#### SITE INSTRUCTION

PROJECT: HAMPTON MANOR

PROJECT NO: 14-016

SITE INSTRUCTION: E-13

GROUND FLOOR PLAN - A **ELECTRICAL**

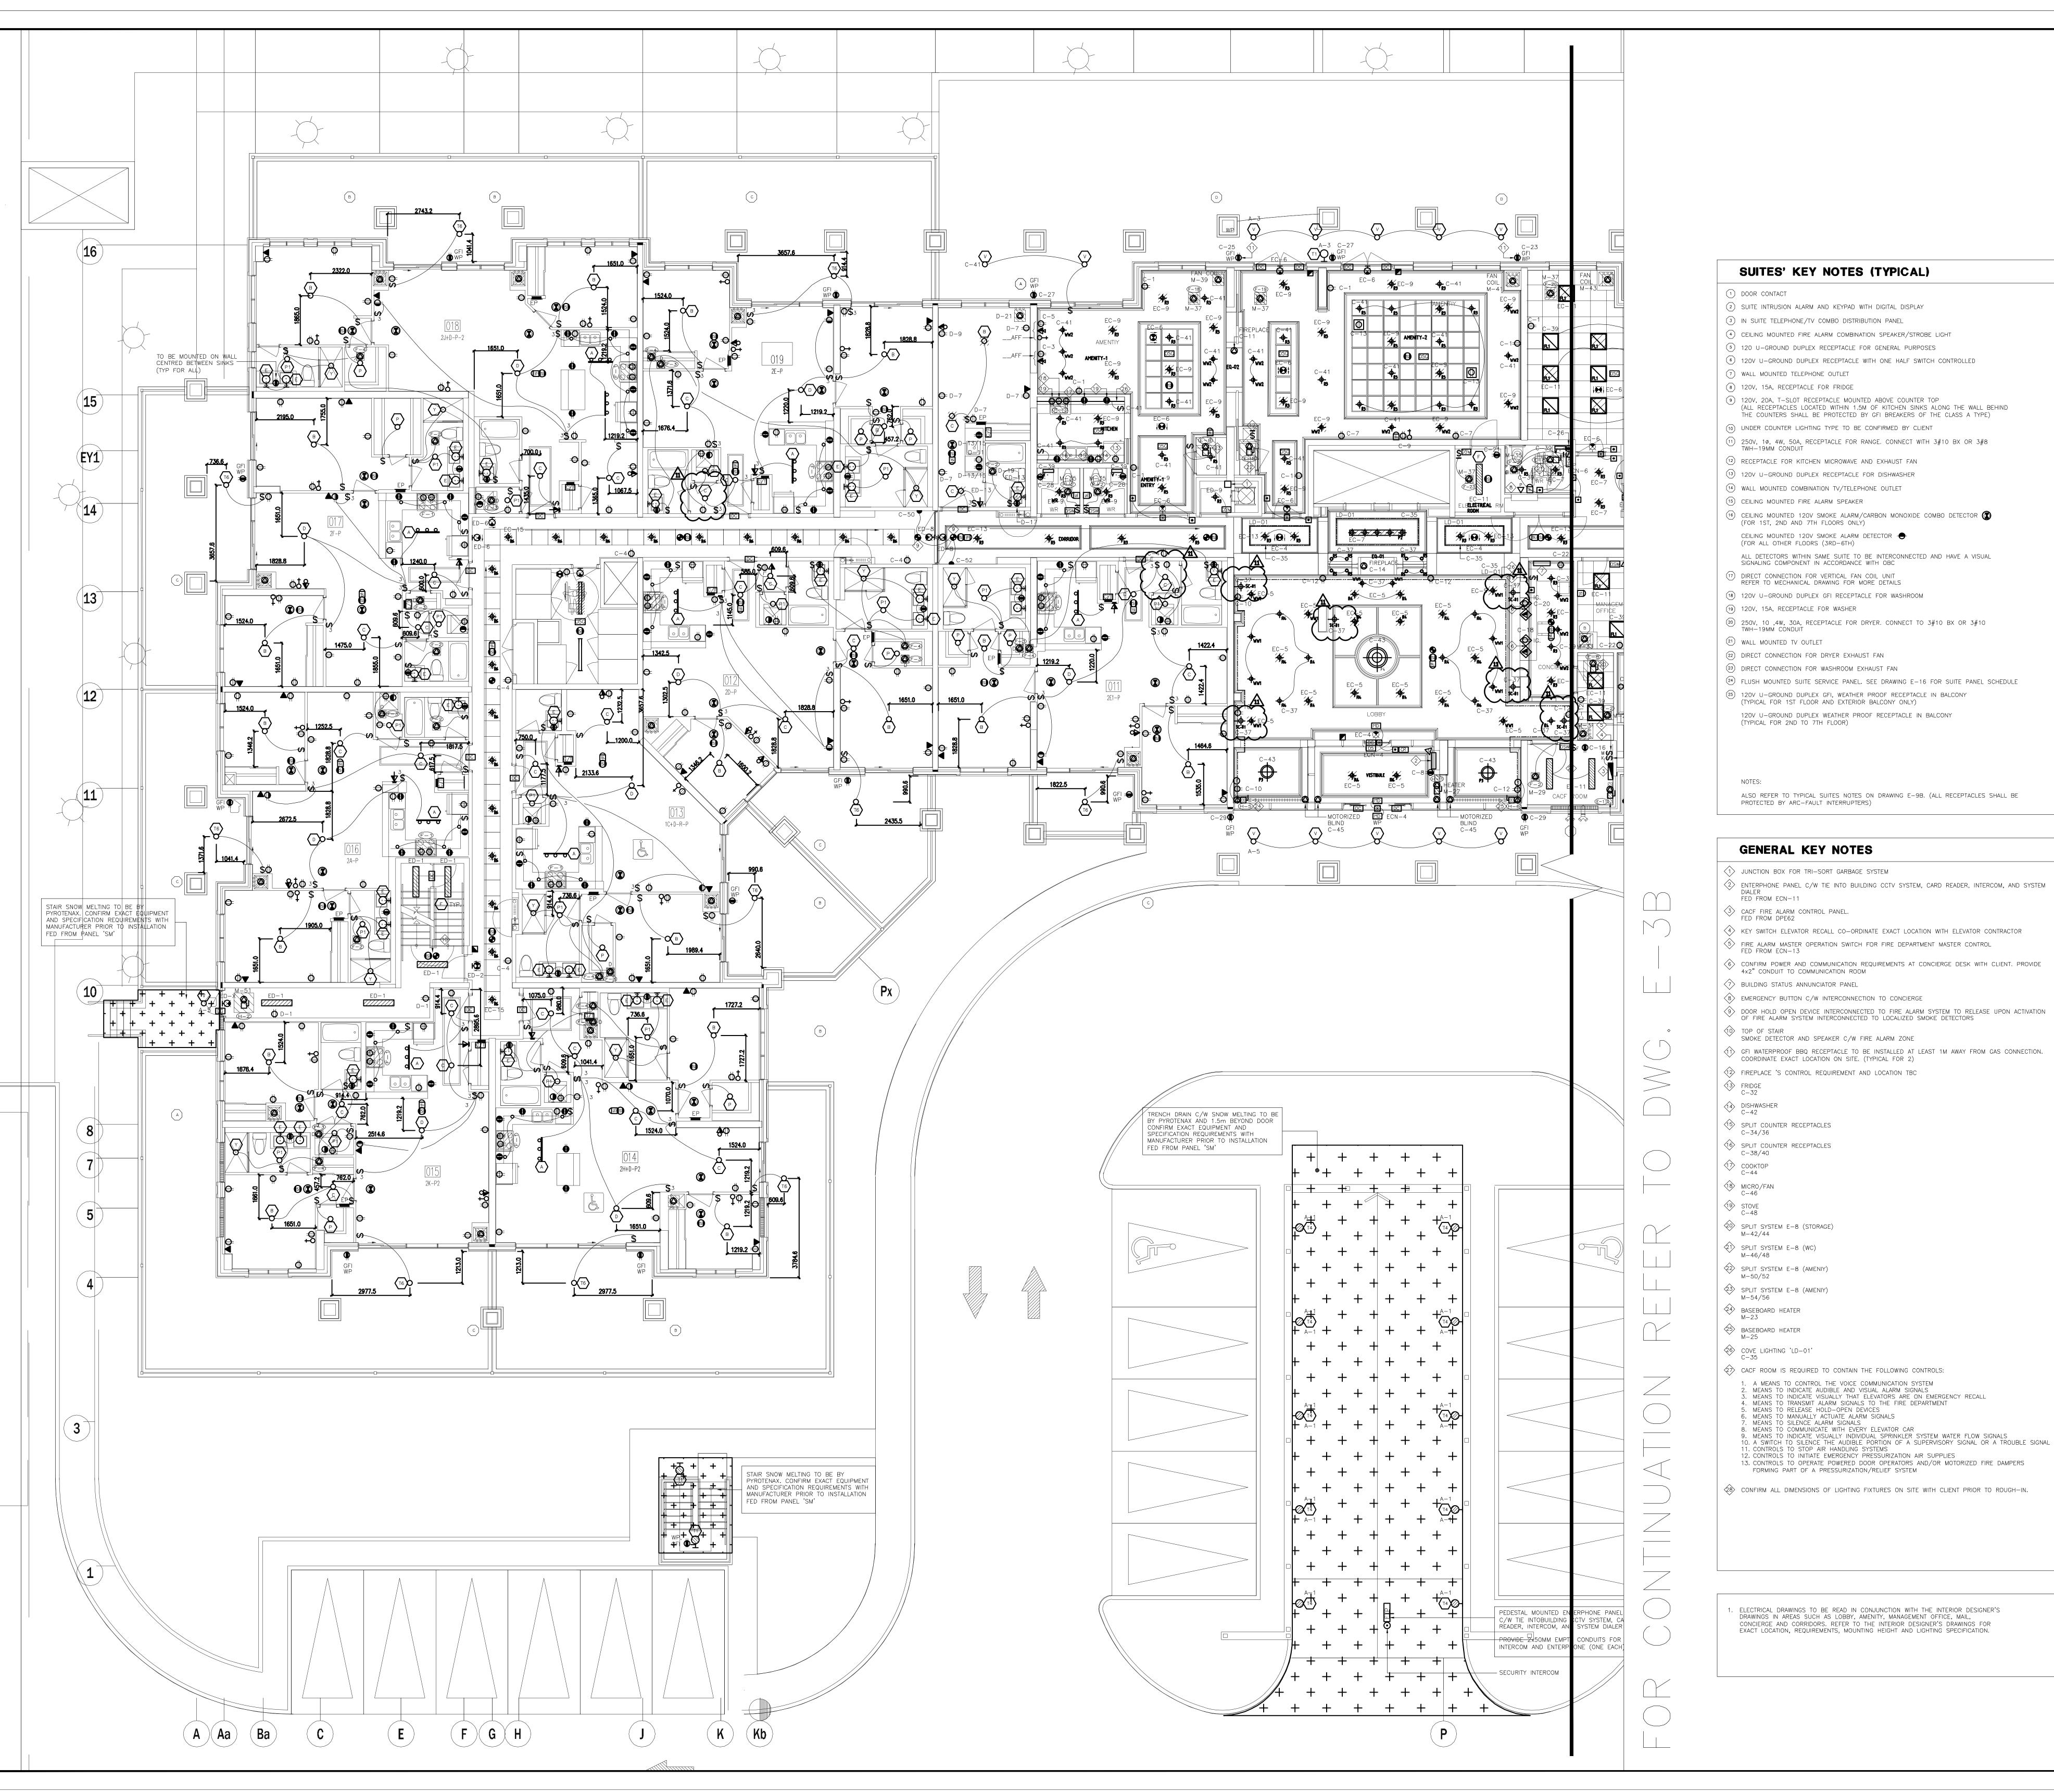
#### 1.0 Reference Drawing E-3A (Ground Floor - A) Issued

1.1 Add:

One (1) light switch and one (1) type 'C' lighting fixture in front of

laundry room in suites 111 and 119.

1.2 Add:

Six (6) type 'SC-01' wall sconce fixtures at lobby.
